## CITY of NOVI CITY COUNCIL

**Agenda Item 5**  
**October 22, 2018**

**SUBJECT:** Consideration for tentative approval of the request of Robertson Brothers Homes, for Lakeview, JSP 18-16, with Zoning Map Amendment 18.723, to rezone from R-4 (One-Family Residential) and B-3 (General Business) to RM-2 (High Density Multiple Family Residential) subject to a Planned Rezoning Overlay (PRO) Agreement, and corresponding PRO Concept Plan. The property is located in Sections 10 and 11, on both the west and east side of Old Novi Road south of Thirteen Mile Road and totals approximately 3.15 acres. The applicant is proposing a new development with 21 single-family detached homes for an overall density of 6.67 dwelling units per acre.

**Figure 1.** City of Novi Regulated Wetland & Woodland Map (approximate project boundary shown in red). Regulated Woodland areas are shown in green and Regulated Wetland areas are shown in blue.

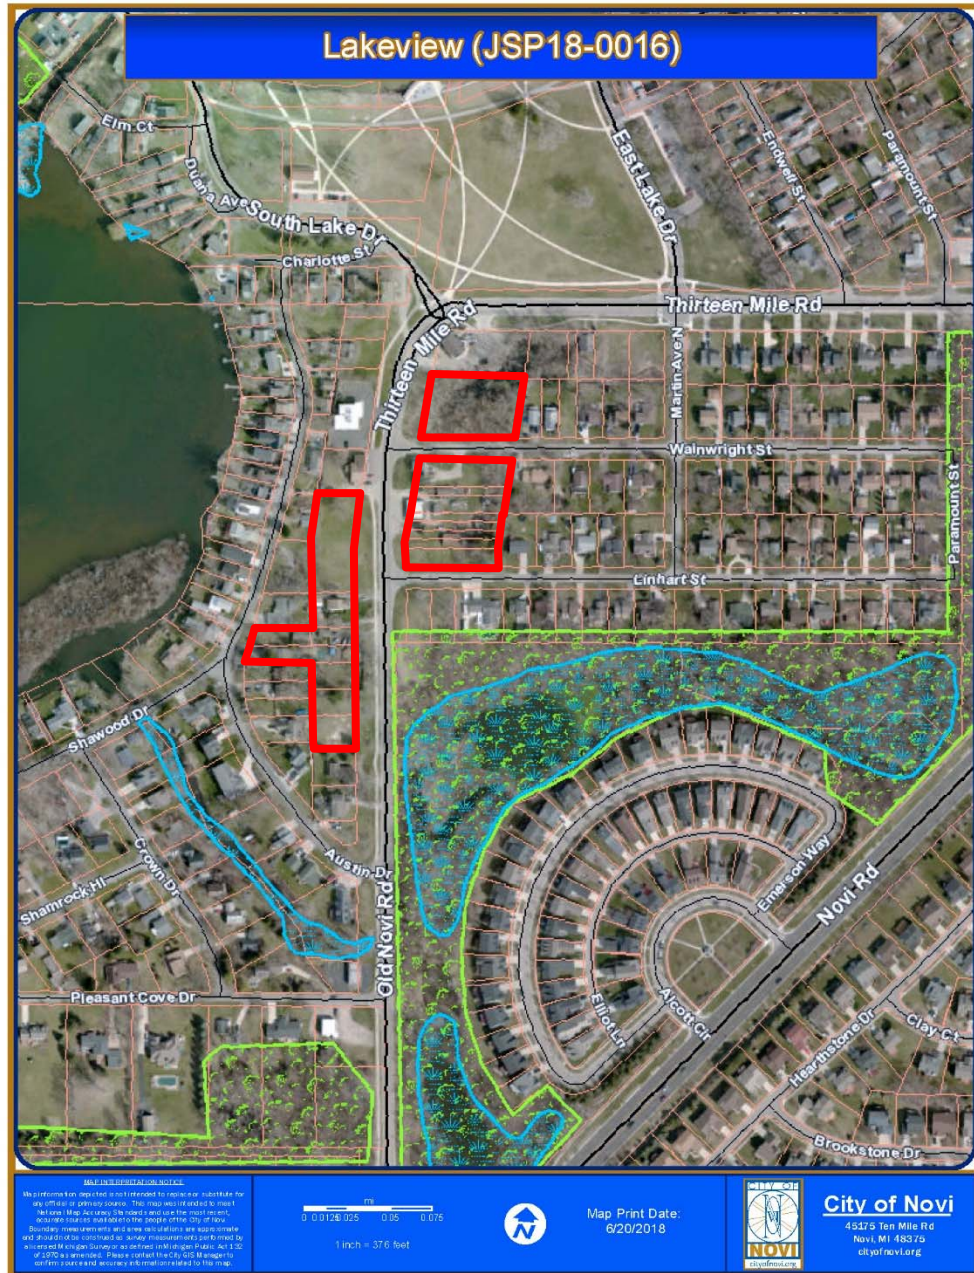
Based on our review of the Plan, Novi aerial photos, Novi GIS, the City of Novi Official Wetlands and Woodlands Maps (see Figure 1, attached) and our on-site evaluation, it appears as if the overall development site contains City-Regulated Wetlands. The BWA *Wetland Delineation and Determination of Jurisdiction* report dated October 3, 2017 notes that one (1) wetland area is present on the parcel and it has been determined that the wetland is subject to regulation by the Michigan Department of Environmental Quality (MDEQ) and the City of Novi. Permits will likely be required by the MDEQ and the City of Novi for construction activities involving this regulated wetland area. It should be noted that this existing wetland area is located on the subject parcel (Parcel C) located east of Old Novi Road and north of Wainwright Street (just south of the existing Lakeside Bar & Grill). This is the only wetland area observed on the proposed parcels being developed.

Although not indicated on the City of Novi's Regulated Wetland Map (see Figure 1), ECT identified one wetland area within the subject property at the time of the site inspection. This wetland was identified by BWA Consulting as Wetland B and wetland flag numbers are indicated as B-1 through B-14 (see Figure 2). The Plan notes that the on-site acreage of this wetland is 6,926 square feet (0.159-acre). The wetland area is an isolated forested/scrub-shrub wetland that contains an emergent depression. Vegetation observed within the wetland included silver maple (*Acer saccharinum*), cottonwood (*Populus deltoides*), box elder (*Acer negundo*), green ash (*Fraxinus pennsylvanica*), nodding beggar-ticks (*Bidens cernua*), and highbush cranberry (*Viburnum trilobum*). Surface water was present at the time of our inspection as well as water stained leaves which are an indicator of wetland hydrology. The applicant's wetland consultant noted that soils pits dug on-site revealed wetland (hydric) soils within the wetland area.

**Figure 1.** City of Novi Regulated Wetland & Woodland Map (approximate project boundary shown in red). Regulated Woodland areas are shown in green and Regulated Wetland areas are shown in blue.

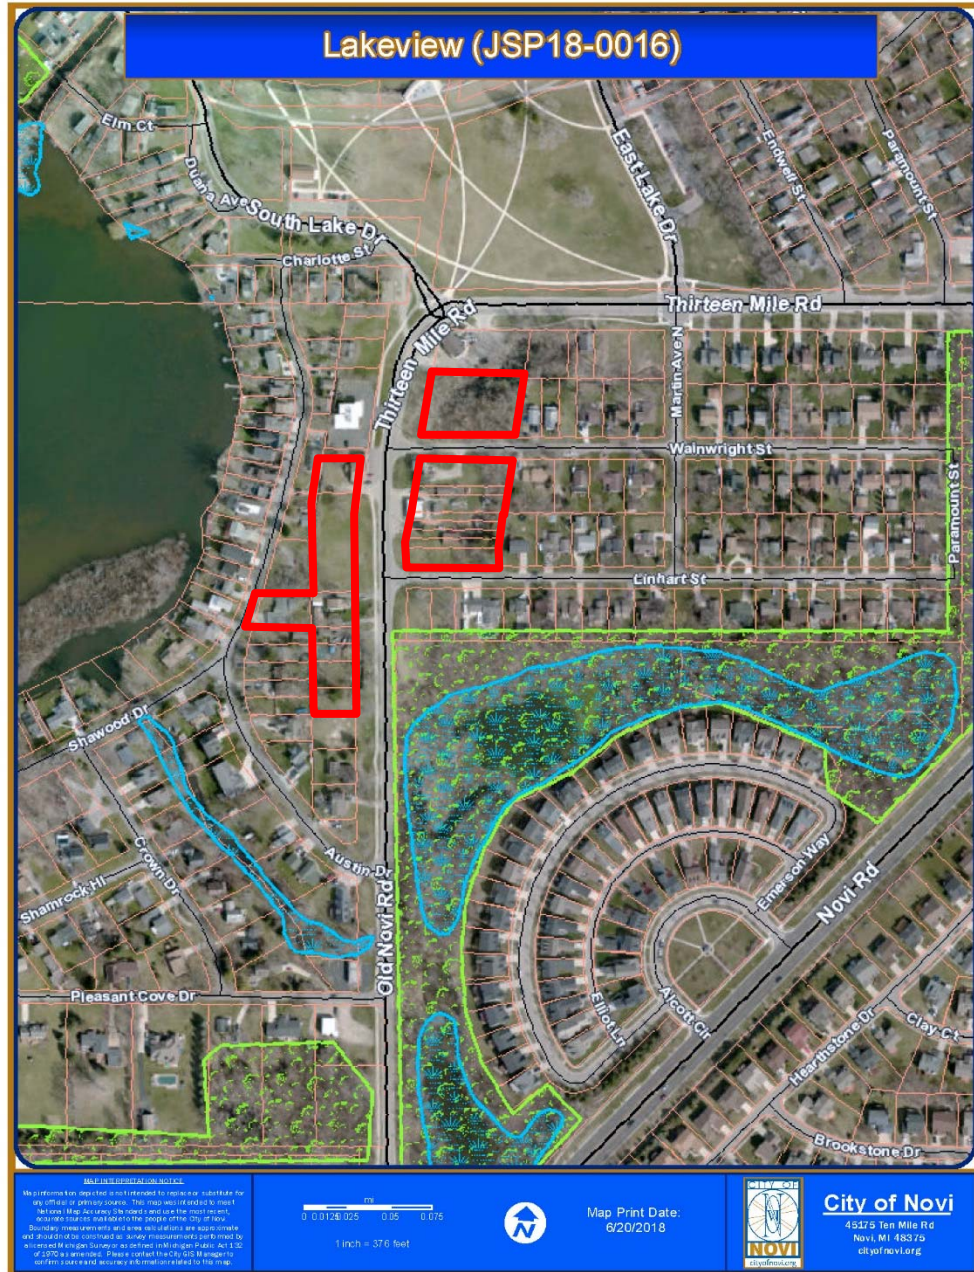
Based on our review of the Plan, Novi aerial photos, Novi GIS, the City of Novi Official Wetlands and Woodlands Maps (see Figure 1, attached) and our on-site evaluation, it appears as if the overall development site contains City-Regulated Wetlands but does not appear to contain areas mapped as City-Regulated Woodlands.

ECT's in-office review of available materials included the City of Novi Regulated Woodland map and historical aerial photographs. The site does not include areas indicated as City-regulated woodland on the official City of Novi Regulated Woodland Map (see Figure 1), however three (3) trees 36-inches diameter-at-breast-height (DBH) are found on the site and are indicated on the Plan. These trees are:
